Rivne 1&2 Lifetime Extension

Environmental Impact Assessment

Final expert statement and
report on the bilateral consultations

REPORT
REP-0767

Figure 1:
Relative contribution of various nuclides to the expected effective dose at 340 km distance during BDBA

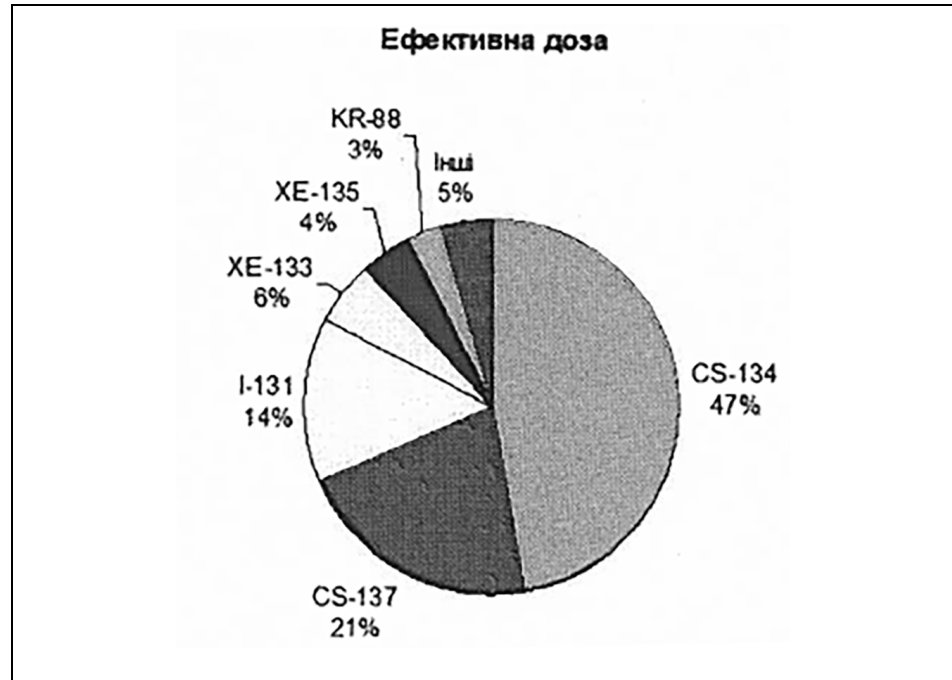
The question is only answered partly. The question aims in particular to the technical justification of the Cs-137 source term (30 TBq). It is confirmed in the ANSWERS (2021) that the limit value of the Cs-137 release was taken as the basis, in accordance with the safety requirements of European operators for the design of a light water reactors but without technical justification for Rivne 1,2. As already explained in UMWELTBUNDESAMT (2021), this assumption is not justified.
